## STAFF REPORT

Request of **Arnold Consulting Engineering Services Inc. (applicant)** for **Shiv Brahma Laxmi LLC (owner)** for a Zoning Map Amendment/Change of Concept Development Plan from Rural Suburban Residential Two/Planned Development (SR-2/PD) and Office Two/Planned Development (O-2/PD) to Office Two/Planned Development (O-2/PD) for an approximate 2.06 acre area located at 56-58 Cavalier Boulevard, Florence, Kentucky. The request is for a zone change/change of concept development plan to allow for the construction of a 50,645 square foot, four story, 122 room hotel.

March 5, 2025

LANDSCAPE PLAN

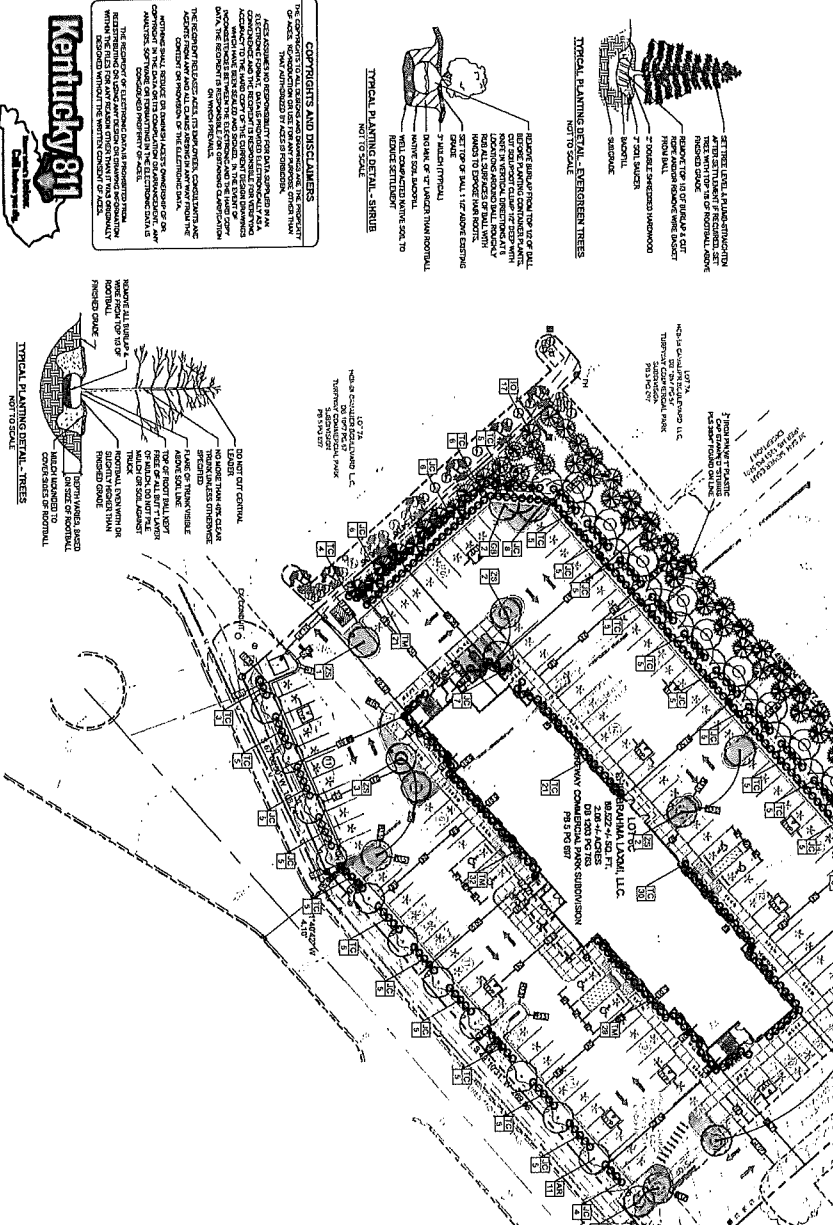
1. The submitted plans indicates that a 6' tall screen fence is proposed in the rear buffer. Can the limits of this fence be defined? We question if this fence is necessary because the adjoining properties contain commercial uses.
2. The planting of trees near utility lines will need to be analyzed in more detail when a Major Site Plan application is submitted for review.

1 - FRONT ELEVATION

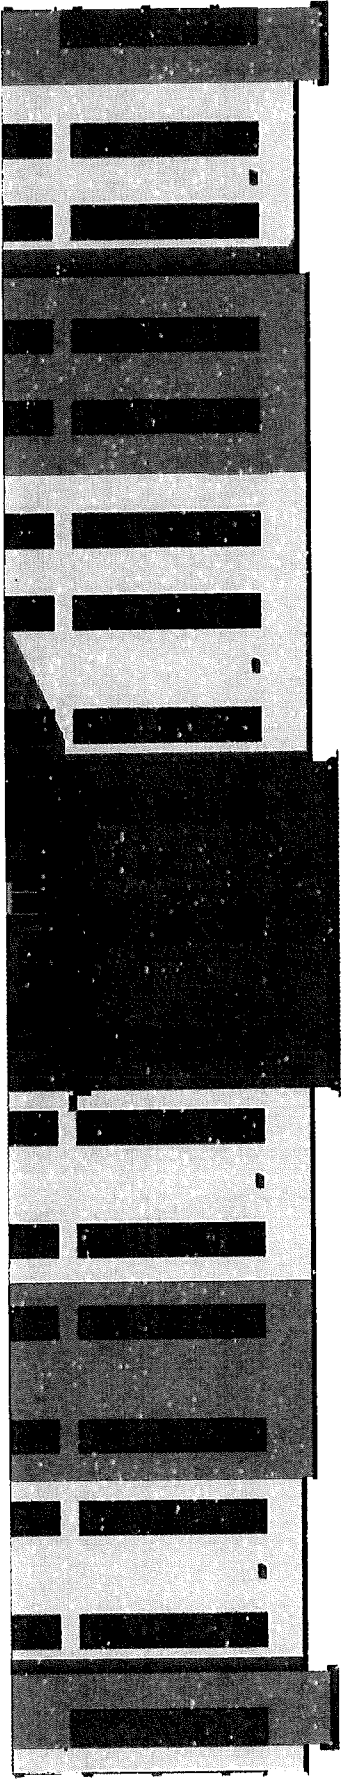
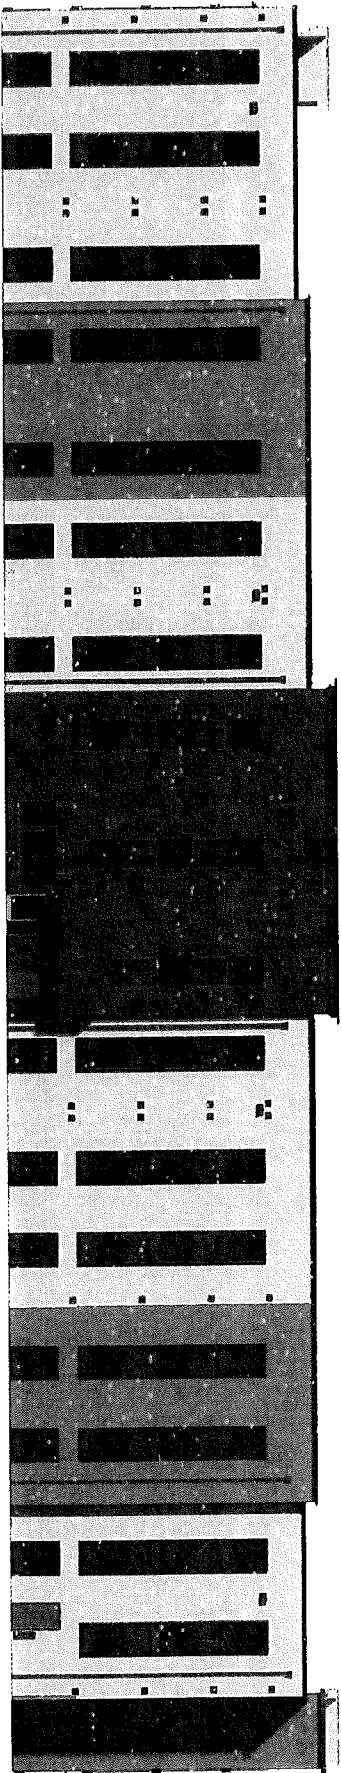
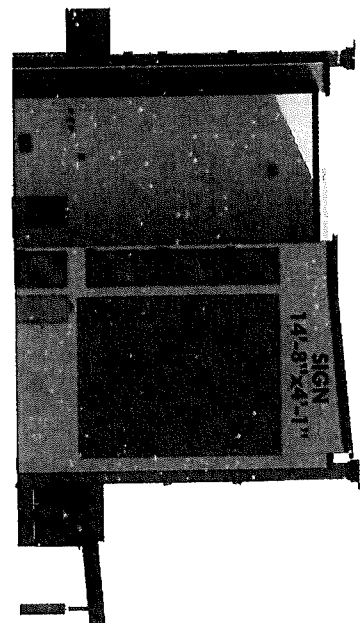
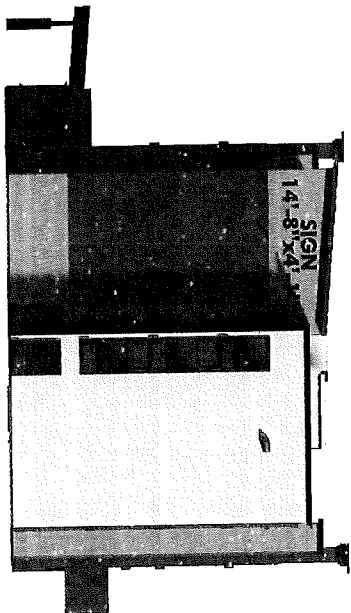
1. The architecture planned development standard requires commercial developments to be constructed predominately with brick, stone, or architectural grade cast concrete products designed to replicate natural materials. The proposed hotel is constructed predominately with colored hard board siding.
2. The building lacks architectural detailing. Equal architectural design treatment is required on all building facades.
3. The final building colors need to be analyzed. The PD zone requires commercial buildings to be constructed with natural colors wherever possible. It's recommended that building areas upgraded with masonry be left unpainted to eliminate maintenance issues.
4. Are rooftop mechanical units proposed? If so, they shouldn't be visible from public view.
5. The sides and rear of the dumpster enclosure need to be constructed with masonry materials, which match the building.

Mr. Daniel Whitley, Arnold Consulting Engineering, Inc., stated that he will provide an open space plan. Is there a minimum amount required? Mr. Schwartz replied no. He will also revise the building elevations to respond to the Planning Commission's and City's concerns prior to the Committee Meeting. The existing Huff monument sign will be relocated to the other side of the driveway due to a new sidewalk. The proposed hotel will only have building mounted signage.
